BROWNS FERRY NUCLEAR PLANT, UNIT NO. 2

AMENDMENT TO FACILITY OPERATING LICENSE

Amendment No. 75
License No. DPR-52

ATTACHMENT TO LICENSE AMENDMENT NO. 75

FIGURE 6.1-1

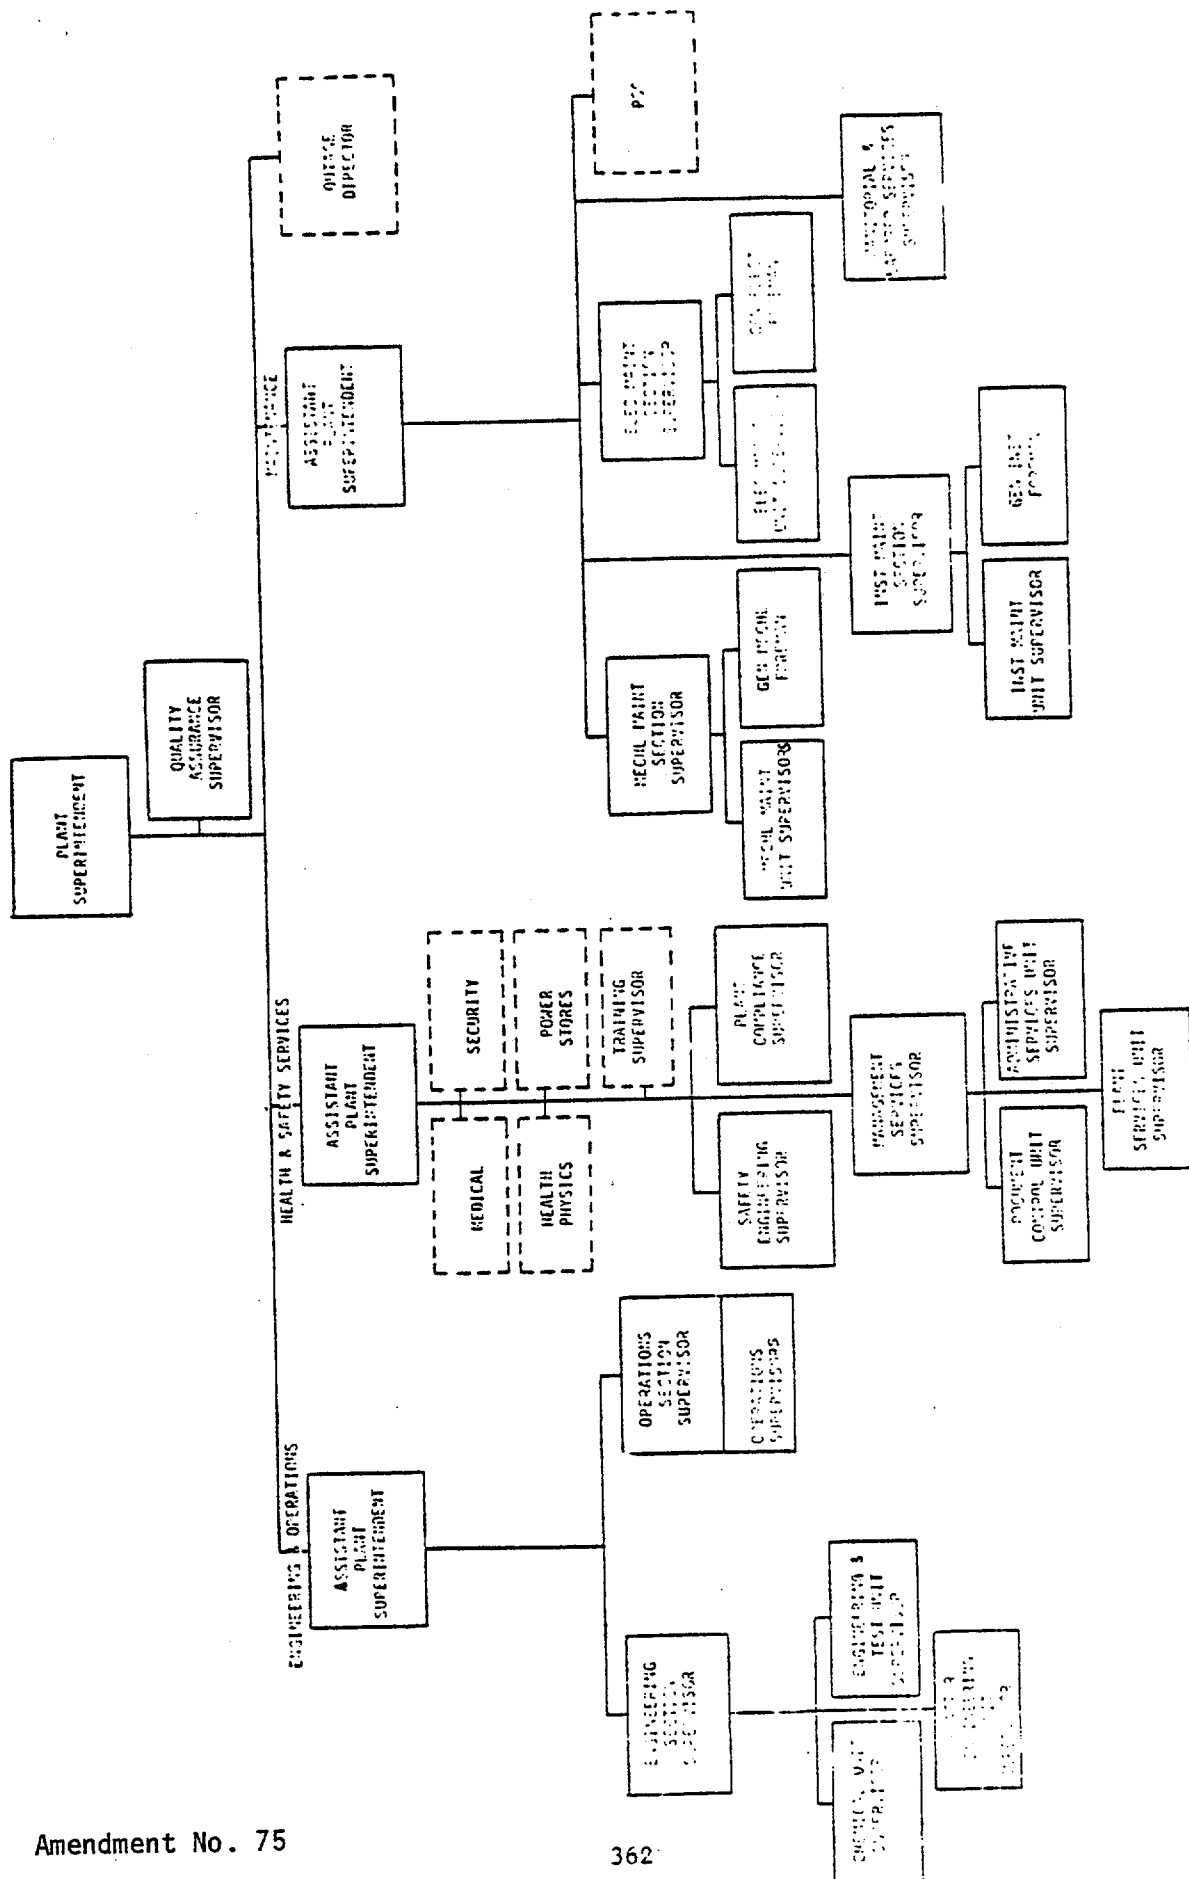
- a. Reflect that TVA's Division of Power Production has been separated into two divisions--the Division of Nuclear Power and the Division of Fossil and Hydro Branch. The former Nuclear Generation Branch is now the Division of Nuclear Power.

— Indicates functional reporting
 Figure 6.1-2

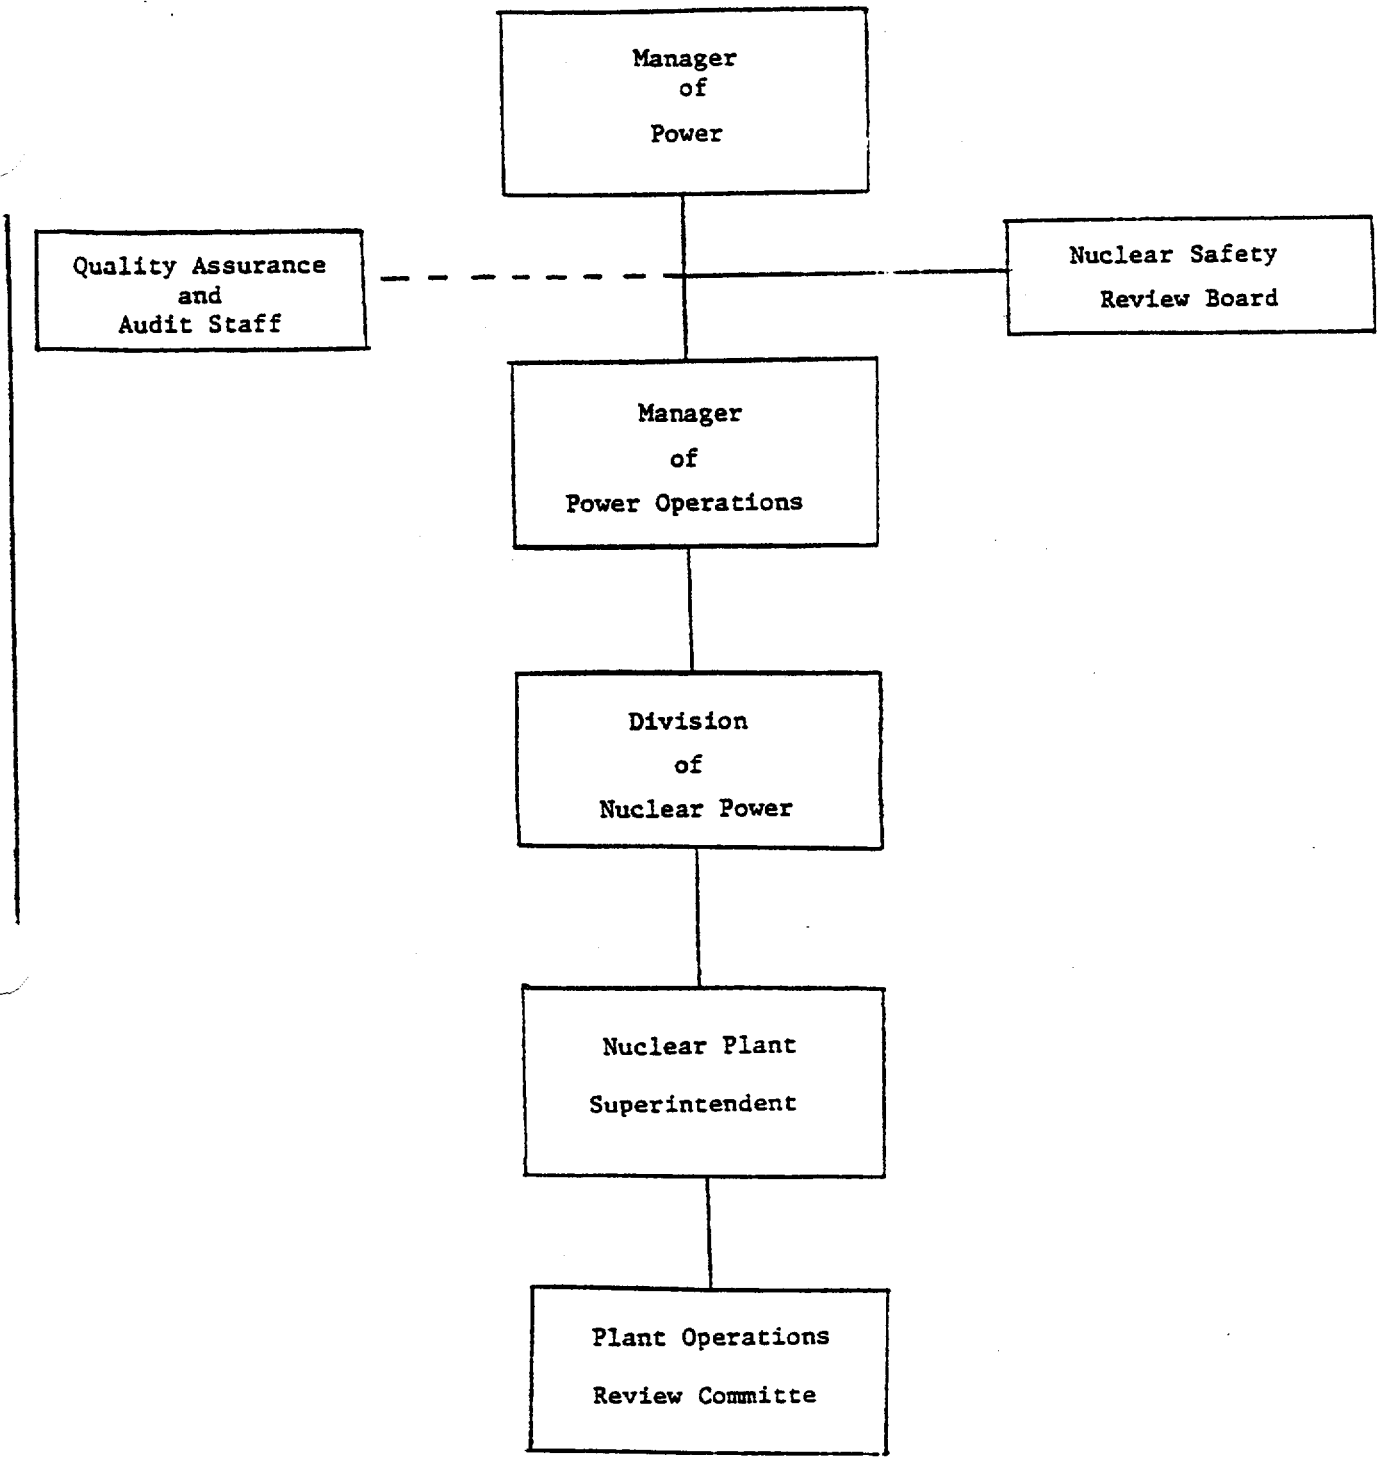
force on site can approach 3,000 people. Initially, BFNP had one assistant plant superintendent. In January 1981 a second assistant plant superintendent was added. Recently, a third assistant plant superintendent was authorized. Section 6.1 of the Technical Specifications is being revised to reflect this change. One assistant superintendent will be responsible for engineering and operations, another will be responsible for maintenance, and the third is responsible for health physics, safety, security, training and administrative services. The health physics organization is placed under the Health and Safety Services, Assistant Plant Superintendent. Thus, the Health Physics Supervisor reports to an assistant superintendent and is independent from plant operations. This is in accordance with the recommendations of Regulatory Guide 8.8, "Information Relevant to Ensuring that Occupational Radiation Exposure at Nuclear Power Stations Will Be As Low As Is Reasonably Achievable" and NUREG-0731, "Criteria for Utility Management and Technical Competence" and is acceptable. The quality assurance supervisor still reports directly to the plant superintendent; there is no change in this area.
